SOUTHERN SANDOVAL COUNTY ARROYO FLOOD CONTROL AUTHORITY

IFB# 2022-03 – Lower Arroyo Venada Bank Stabilization Project

ADDENDUM #2

December 22, 2022

5 SHOTCRETE CHANNEL SLOPE TYPICAL SECTION
Scale: NTS

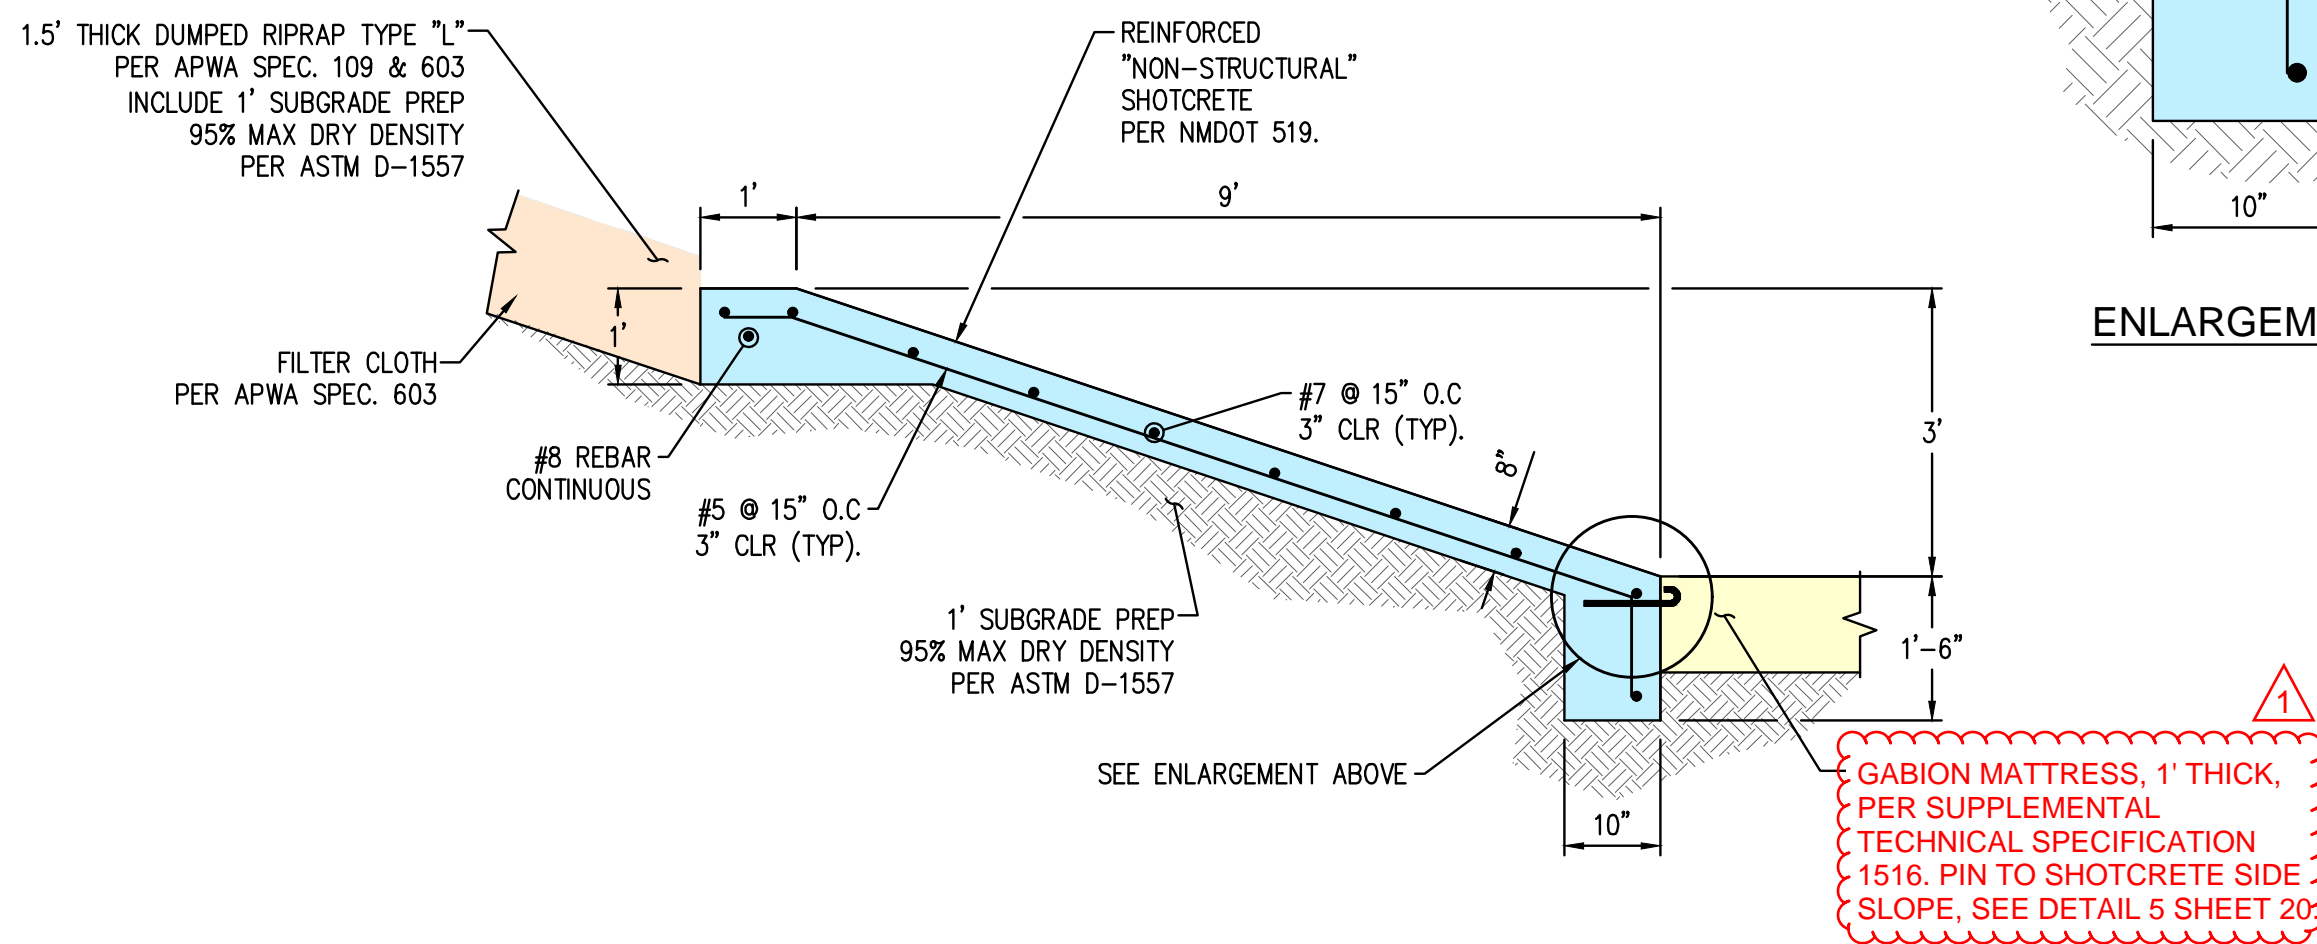
Q1: Can 3,000 psi Class “A” concrete be substituted for the 3,000 psi shotcrete?

A1: Yes. The 3,000 psi shotcrete may be substituted for 3,000 psi Class “A” concrete with a tined finish.
